SpaceX Responses (STA File Number: 1721-EX-ST-2022)

Here the EIRP masks of the initial application for reference:

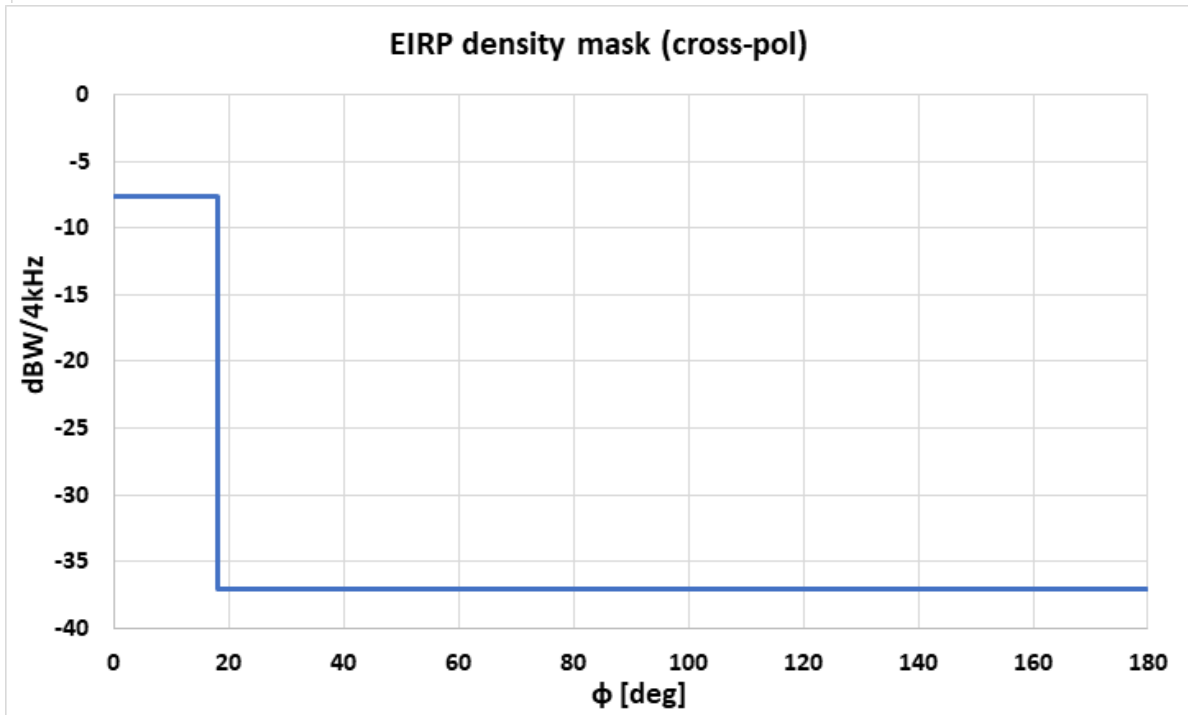
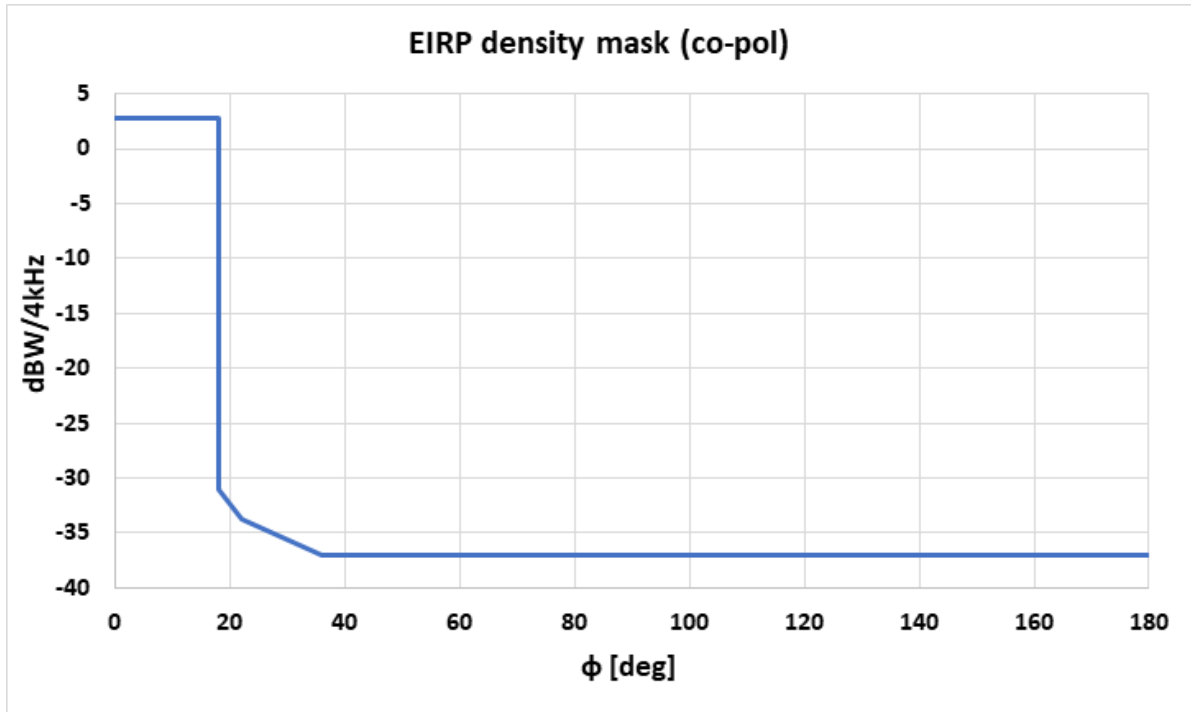
- (2) Please Provide SpaceX phased array antenna's pattern performances:**

(a) Please provide the co-polarized gain (dBi) with an individual scan angle (elevation angle (°) and skew angle (°)), plus and minus from 0 to 10 degrees, 0 to 45 degrees, and 0 to 180 degrees with FCC 25.209 envelop superimposed on each measured pattern, in the azimuth and elevation planes. Please provide the on-axis gain that exceeded the FCC 25.209 on-axis gain mask. Please provide the off-axis gain that exceeded the FCC 25.209 off-axis gain mask.

(b) Please provide the Off-axis EIRP density envelopes (dBW/MHz) and/or (dBW/4 kHz) with an individual scan angle (elevation angle (°) and skew angle(°)) (ESD mask), plus and minus from 0 to 10 degrees, 0 to 45 degrees, and 0 to 180 degrees with FCC 25.218(f) envelop superimposed on each measured pattern, in the azimuth and elevation planes. Please provide the Off-axis EIRP density that exceeded the 25.218(f) envelop.

(c) Alternately, please provide applicant's "defined" Off-axis EIRP density envelopes (dBW/MHz) and/or (dBW/4 kHz) with an individual scan angle (elevation angle and skew angle) (ESD mask), plus and minus from 0 to 10 degrees, 0 to 45 degrees, and 0 to 180 degrees with FCC or ITU envelop superimposed on each measured pattern, in the azimuth and elevation planes:

SpaceX provided EIRP density masks in its initial application. SpaceX did not depict the 25.209 envelope, because it does not apply to NGSO user terminals.
